St. Mark's Street Park Working Group (SMSPWG)

Meeting Minutes

May 16 2023

PLAN AND DETAILS FOR
SOUTHBOROUGH HISTORY WALK - ST. MARK'S PARK
IN THE TOWN OF
SOUTHBOROUGH
WORCESTER COUNTY

**SOUTHBOROUGH
SOUTHBOROUGH HISTORY WALK
PARK
PLANTING PLAN
SHEET 4 OF 8**

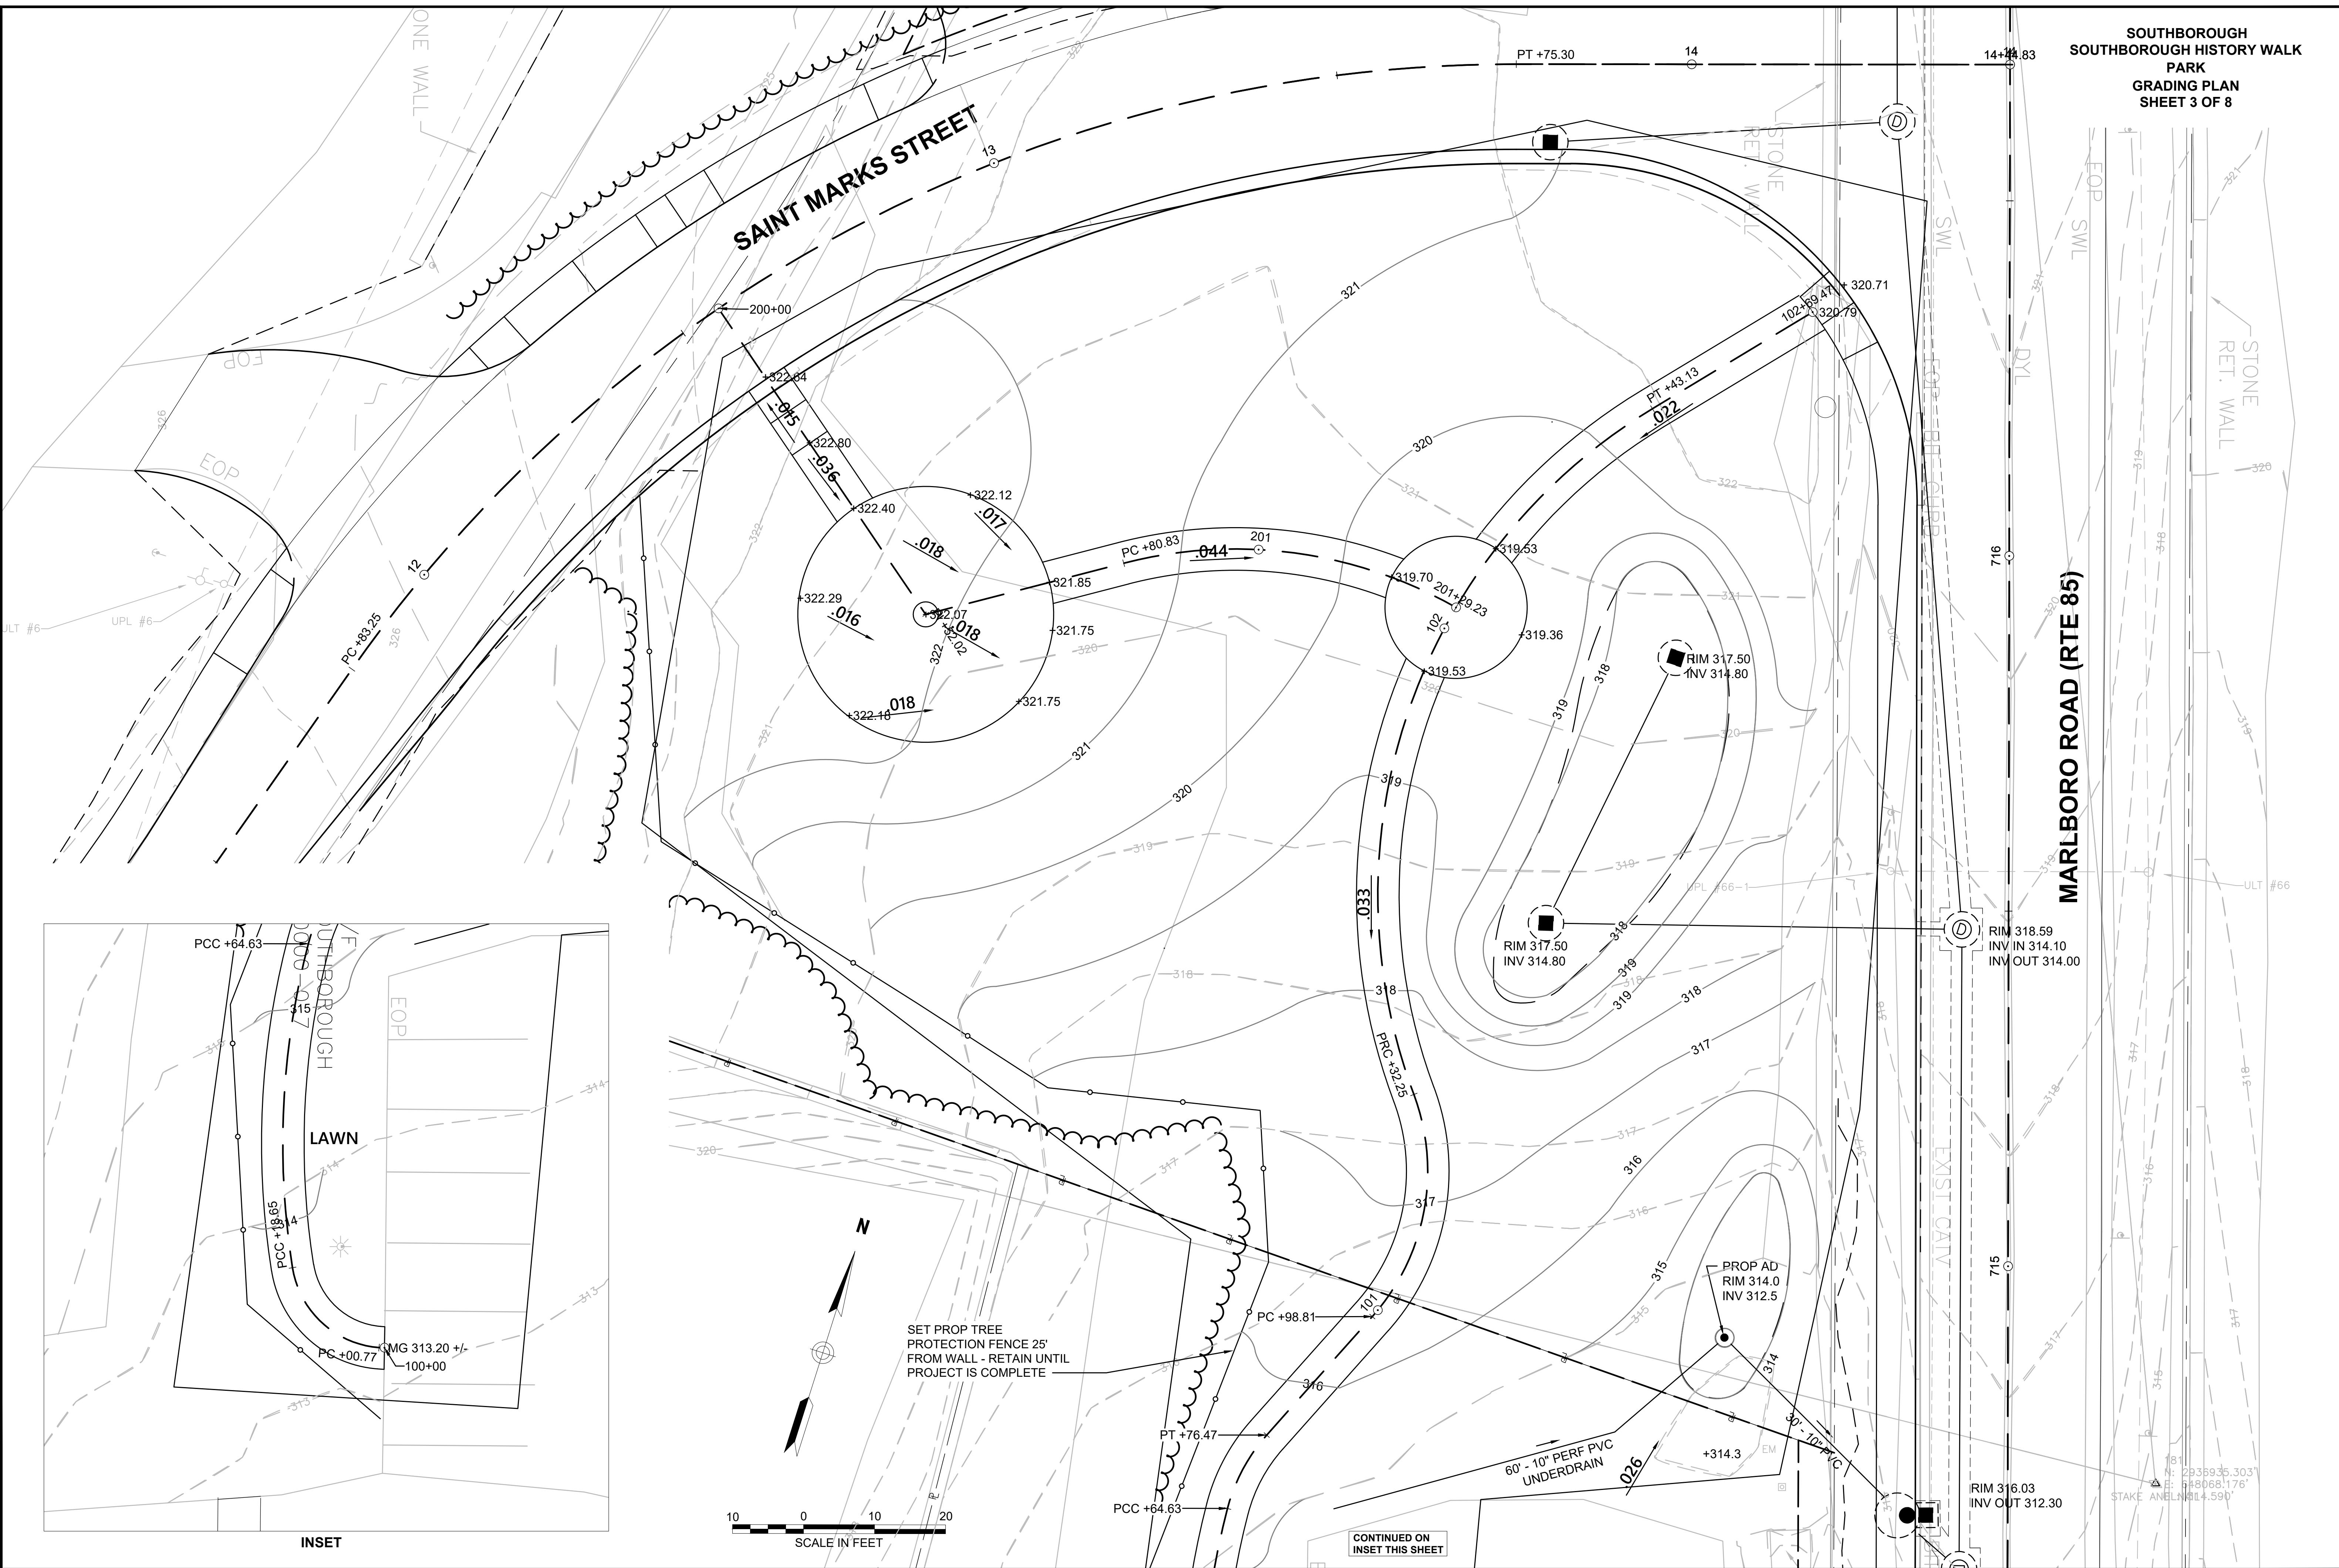
I support Michael Weishan suggestion to use *Ilex opaca* (American holly) in the planting. It was in the plan I submitted last winter. You would need at least, 2 one male and one female to get the berries. This tree is on Dr. Gegear's list of plants for at-risk pollinators.

I would not support the disease resistant elm as they are Hybrid Asian elms and therefore not native. I recommend a red maple if you want to diversify the 3 oak trees. It is a tree I recommended in the past, and it is also a Dr. Gegear researched and recommended plant to preserve biodiversity.

Therefore, the problem the line of evergreen trees is trying to solve, is a problem that doesn't exist. However, the solid wall of evergreens will debase the value of the park by blocking not only the scenic view as you drive into town, it negates the intention of the history walk; when you try to look at the Old Burial Ground or Pilgrim Church you will only see a wall of evergreen trees year round.

Instead of the evergreen blockade fence, in that area I suggest using shrubs of various heights that don't interfere with the view, and will create a thicket for birds for refuge, foraging for seeds and berries, and nesting habitat as well as pollen and nectar for pollinators. One of the best for this area would be *Rubus odoratus* (Purple Flowering Raspberry) which is wonderful for birds as well as pollinators. I previously provided a list which I can resend if you'd like. The *Diervilla lonicera* (native bush honeysuckle) is a wonderful small shrub with fantastic foliage. That could also be used in this area.

I would replace the shade tree and go with what I previously recommended as a better choice, change the flowering trees back to *Cercis canadensis* (Eastern redbud) as these trees are one of the first trees to bloom in the spring providing critically important nectar that our most at risk pollinators are dependent on. Redbuds are not only beautiful when in bloom, they have lovely heart shaped leaves, which turn a golden yellow in autumn, giving a nice pop of color. Songbirds eat the seeds.

The list for the rain gardens has great choices from Dr. Gegear's list, but I question including *Baptisia tinctoria* in the rain garden as it likes dry and sandy conditions, indigenous to oak barrens, it might do well to plant up in higher grounds around the base of the oak trees. I would replace it in the rain gardens with a plant that can handle getting its feet wet, there are a lot on Dr. Gegear's list, I'd suggest a combination of button bush for the wetter area lower in the rain garden (even one would be nice) and then *Spiraea tomentosa* (Steeple bush).

'Cape Breeze' Switch Grass is a cultivar, the straight species should be used.

In Addition, he has also suggested using a plant like American Holly in place of some of the white spruce in the line of evergreens mean to protect the Old burial ground from wind damage. He said it was too homogenous-looking to have all white spruce trees there.

7. Group vote to send the current plan to the Select Board to put out to bid at their 5/23/23 meeting, or as soon as possible, with changes as noted in the minutes above (Moving path to save one tree, adding red maples in place of an oak tree, layering trees instead of all evergreen trees, modifying rain gardens and bushes, and removing the Granite Memorial Medallion). The Group further recommends looking into putting in new stone walls.
